Pre-Bid Clarification-1**Tender Enquiry No. PROC-FB-CB-PROD-4781/2020****Description : UNDERGROUND WARNING TAPE FOR PIPELINE****Bidder Query:**

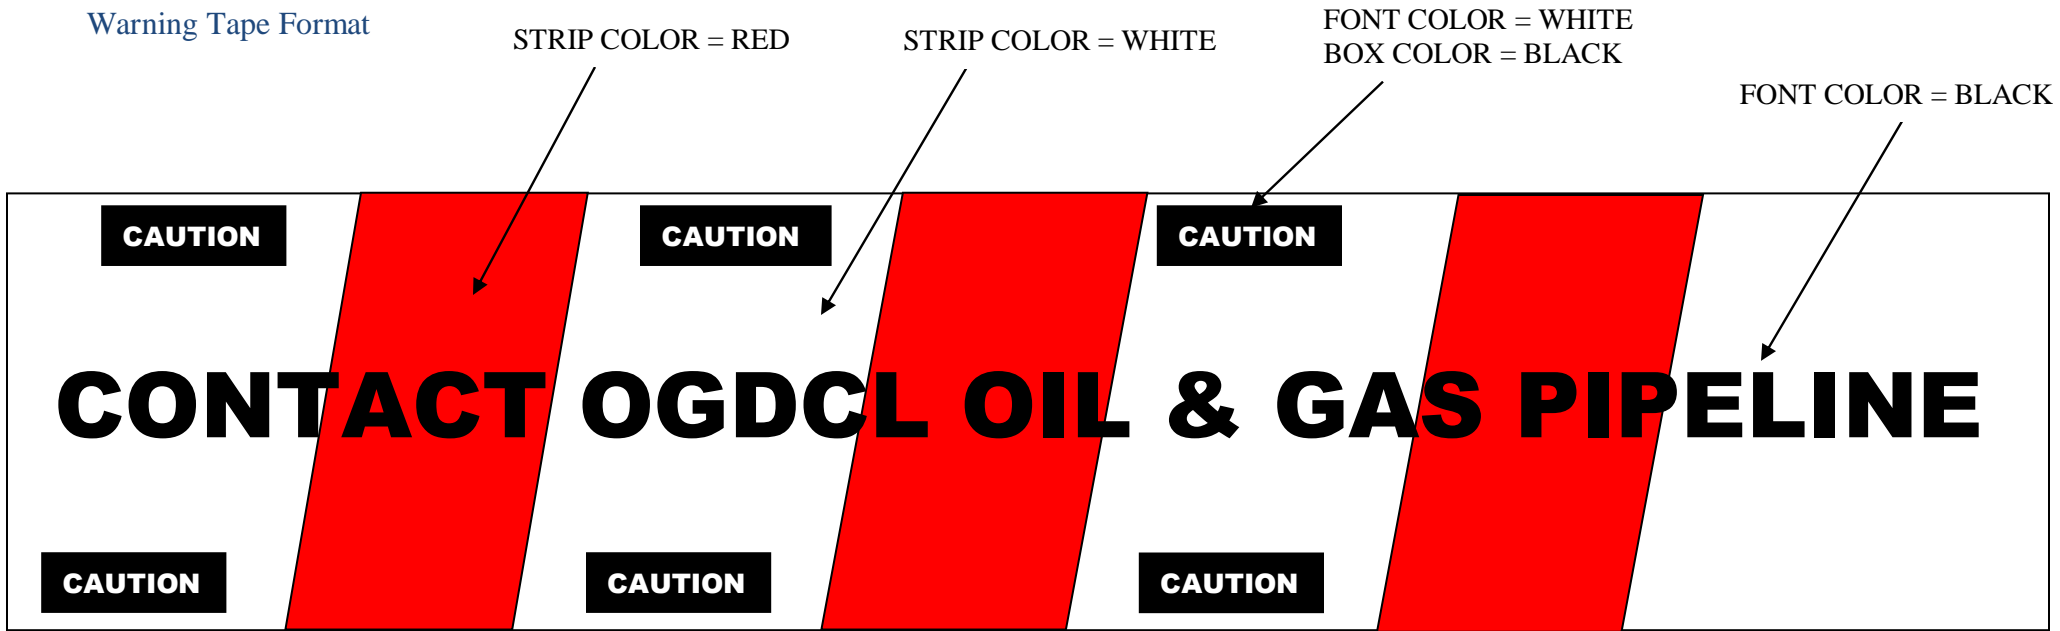
1. One side printing OR double side printing?
2. Packaging type?
3. Is the tape detectable (tracer wire) or non-detectable?
4. Confirmation of design details of the warning tape?

1. Double side printing.
2. Shrink packaging (individual roll in a shrink packaging) with transparent bag and then put into carton.
3. Non-Detectable.
4. Design details attached.
